ASSESSMENT REPORT

Taralga Wind Farm - Modification

(DA 241/04 MOD 7)

Figure 3: Riparosso Road Upgrade

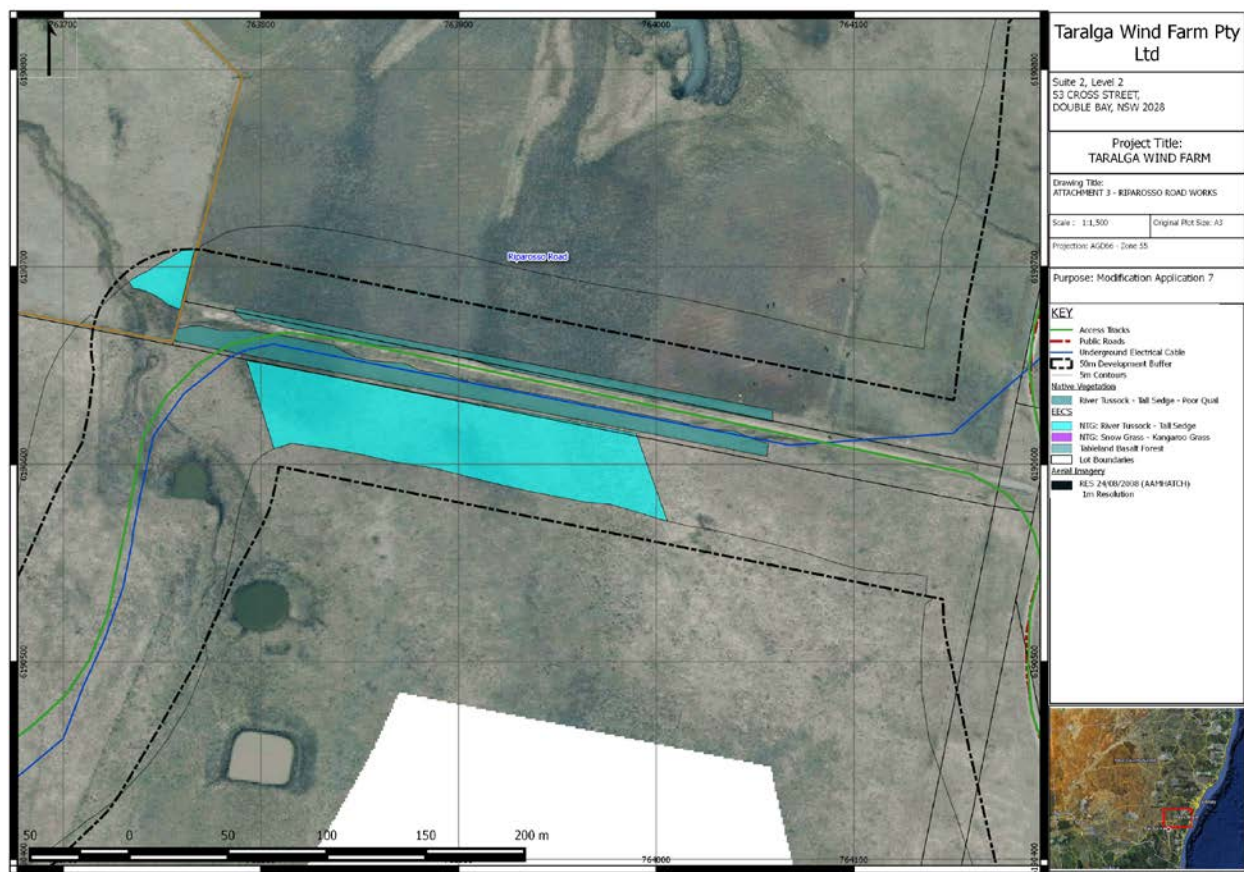
Taralga requires access for construction vehicles along Riparosso Road in order to construct two turbines (T56 and T58) that were part of the original approval. The current road is unsuitable for construction vehicles (see Figure 5), and it is necessary to undertake a range of upgrade works within the road reserve, including widening the road to 5.5 metres, importing gravel for the road base, and installing culverts. The need to upgrade local access roads was contemplated in the original EIS for the project, and Council has issued a Section 138 approval under the *Roads Act 1993* for the proposed works.

Overall, the Department considers that the request to allow a local road to be upgraded within an existing road reserve is entirely reasonable, and the restriction on undertaking works within 50 metres of the Natural Temperate Grassland should be removed in this location to allow the project to be constructed as approved. The Department also considers that the proposed works would have no material impacts on Natural Temperate Grassland or other biodiversity values in the vicinity.

Figure 4: Bannaby Road Cable Re-Alignment

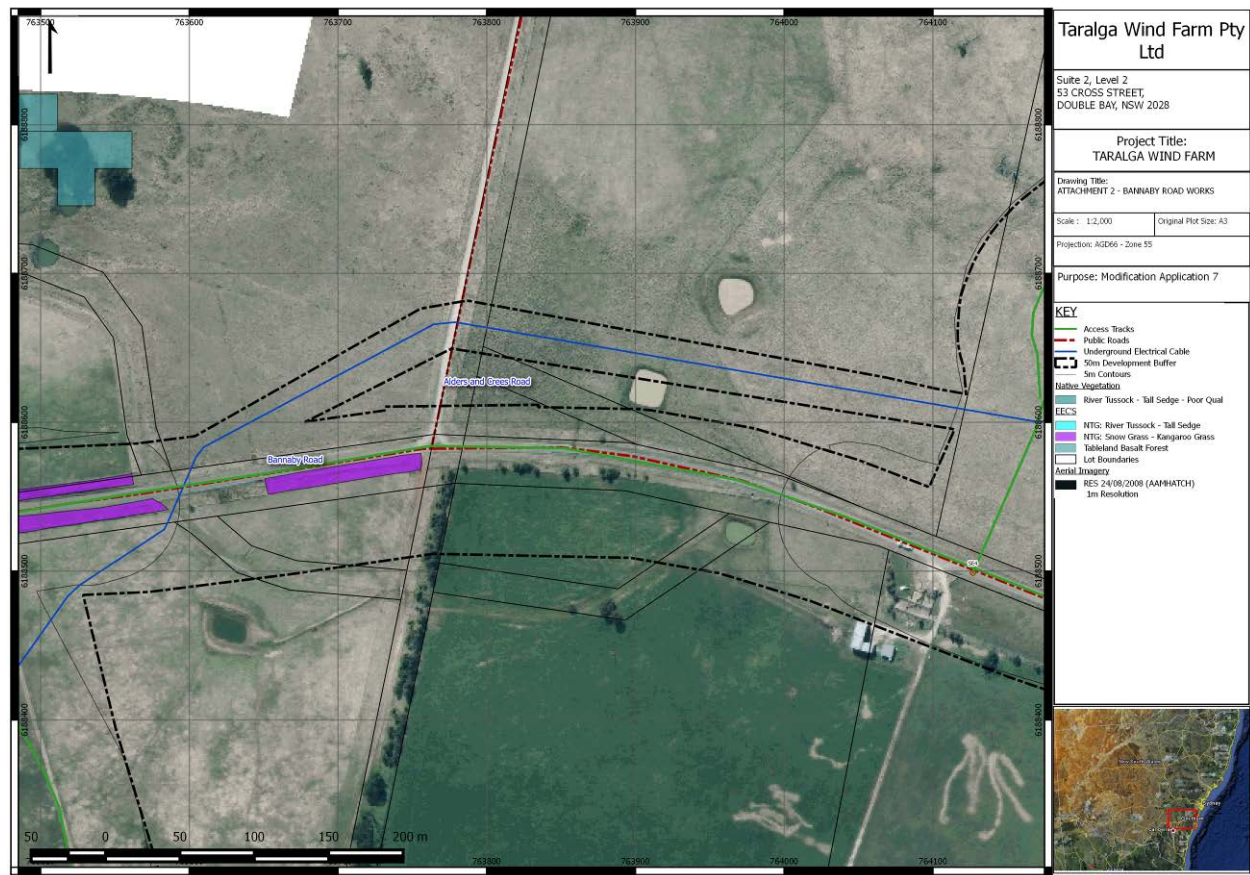
The proposed realignment of a 640 metre section of the underground electricity cable to the north of Bannaby Road would be located on disturbed pasture land. While detailed biodiversity surveys have not been undertaken along the re-alignment, both the Department and OEH consider that any vegetation would be highly disturbed and likely to be of low conservation value. Furthermore, given that the maximum native vegetation disturbance footprint would be less than 0.2 hectares, and that the alignment would be re-instated following construction, the Department considers that any impacts on biodiversity would be negligible.

The area within the road reserve is highly disturbed and of very low archaeological sensitivity. The Department notes that Taralga has committed to maintaining a distance of 100 metres between the road upgrade works and the nearest Aboriginal site (TWF OS4 with PAD), in accordance with its approved CEMP. In regard to the proposed cable re-alignment, the Department notes that the nearest Aboriginal heritage site (TWF OS1) is more than 100 metres from the proposed route (see Figure 6).
